UNITED STATES PATENT AND TRADEMARK OFFICE

APPLICATION NO.	FILING DATE	FIRST NAMED INVENTOR	ATTORNEY DOCKET NO.	CONFIRMATION NO.
10/810,203	03/26/2004	Ho Yong Kang	2013P160	8669

Office Action Summary	Application No. 10/810,203	Applicant(s) KANG ET AL	
	Examiner David S. Kim	Art Unit 2613

DETAILED ACTION

FIG. 5

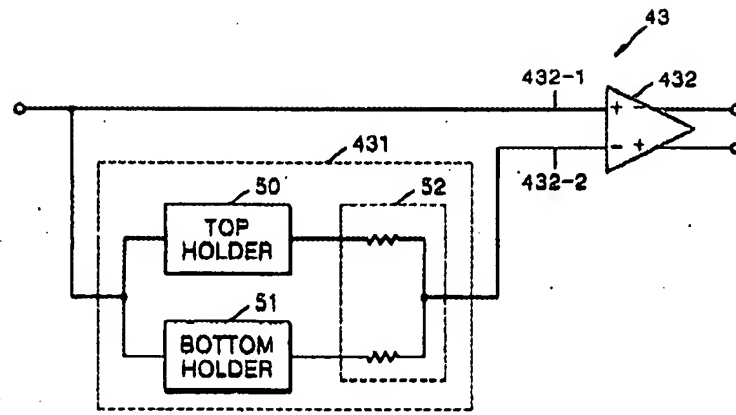
- 1) The connections from the peak value sensor to the error amp in Figs. 6-7 are not supported. As a simple remedy, Examiner suggests the simple removal of these connections.
- 2) The connections from the error amp to the output lines in Figs. 6-7 are not supported. As a simple remedy, Examiner suggests the simple removal of these connections.

FIG. 6

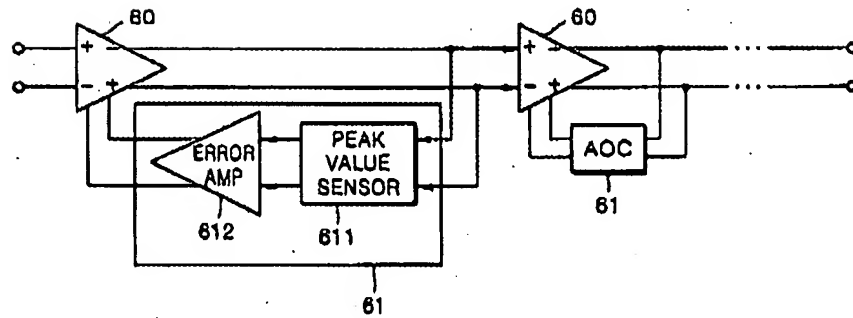
Disapproved by DSK
21 August 2007
